**FAX TRANSMITTAL**DATE: August 17, 2008PAGES: 3 (including this page)TO: Plan HoldersFROM: Castellaw Kom Architects**ADDENDUM NUMBER TWO****August 17, 2009**

**Paint Towers  
Idaho Public Television  
Moscow and Jerome, Idaho****Moscow Tower  
Jerome Tower  
DPW Project Number: 08-280  
Architect's Project Number: 09039**

**PROJECT**  
PAINT TOWERS  
IDAHO PUBLIC TELEVISION  
MOSCOW TOWER

SHEET ♦ ADDM #2  
A1

## MOSCOW TOWER ELEVATION

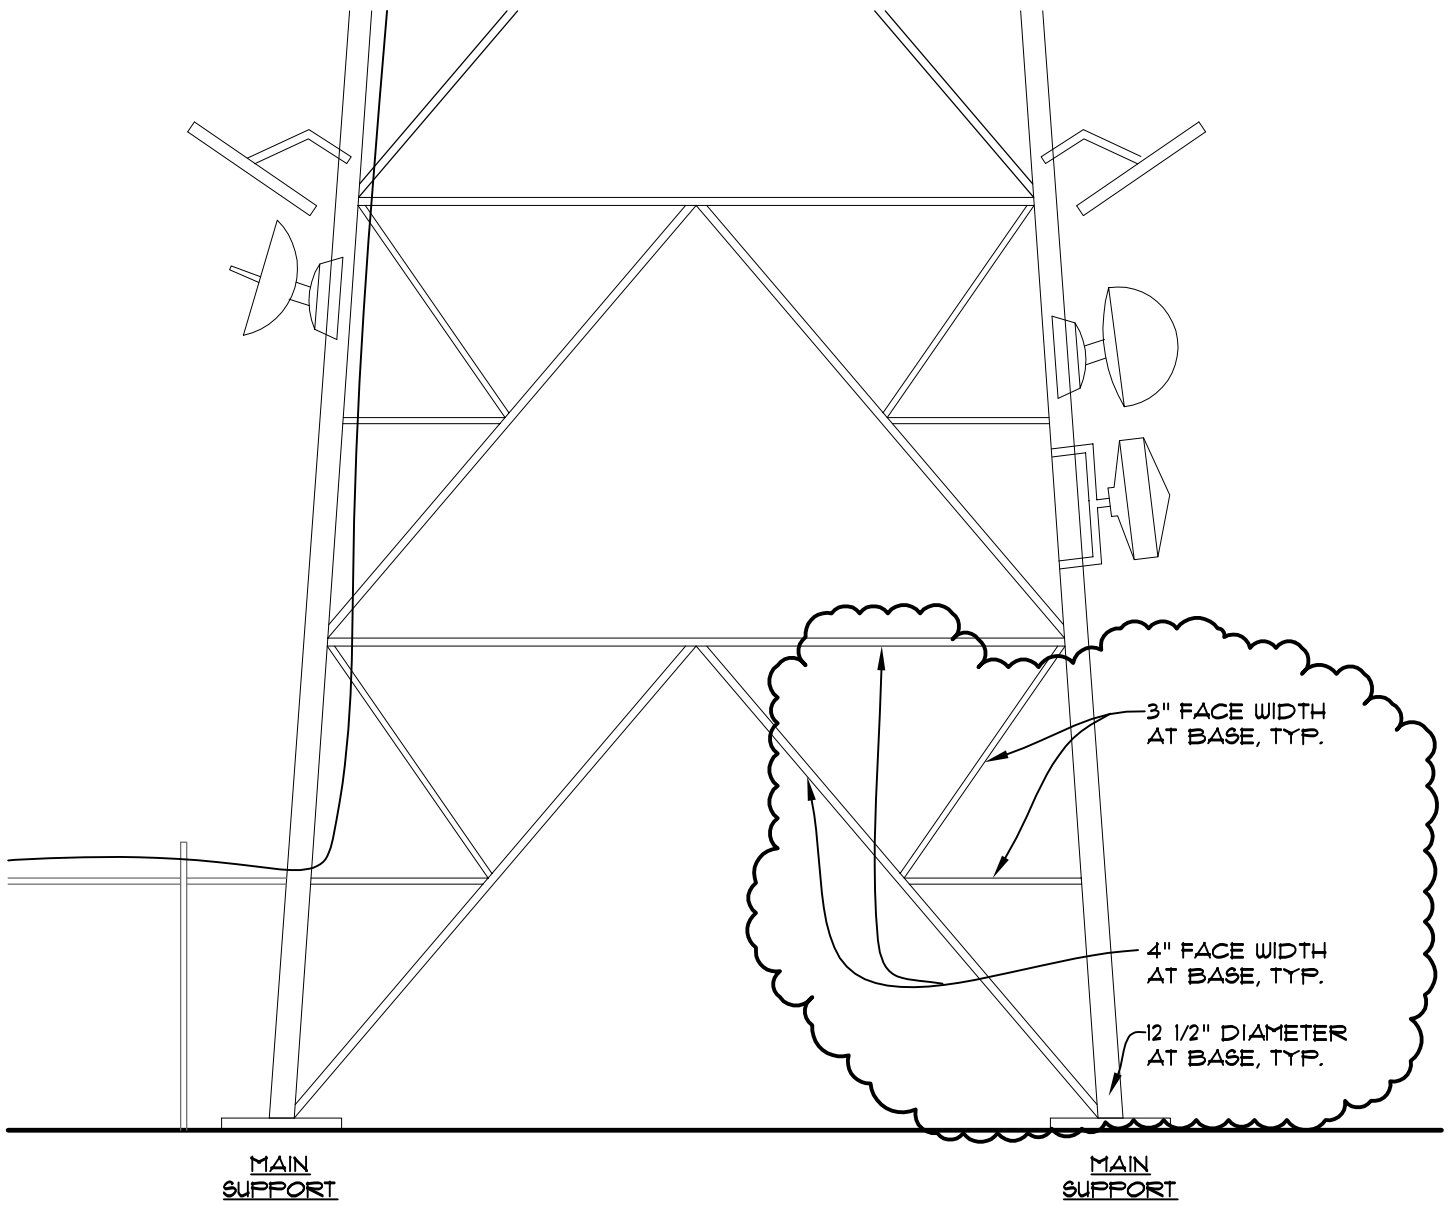
1. Tower Elevations: **Clarification:** Face width at base of existing members - see attached drawing. Existing top members for the Moscow Tower have a face width of approximately 6".
2. Tower Elevations: **Clarification:** Existing legs of Moscow Tower have a 12 3/4" diameter at the base (3' - 4" circumference) – see attached drawing. Existing legs of Moscow Tower have a diameter of approximately 8" at the top.
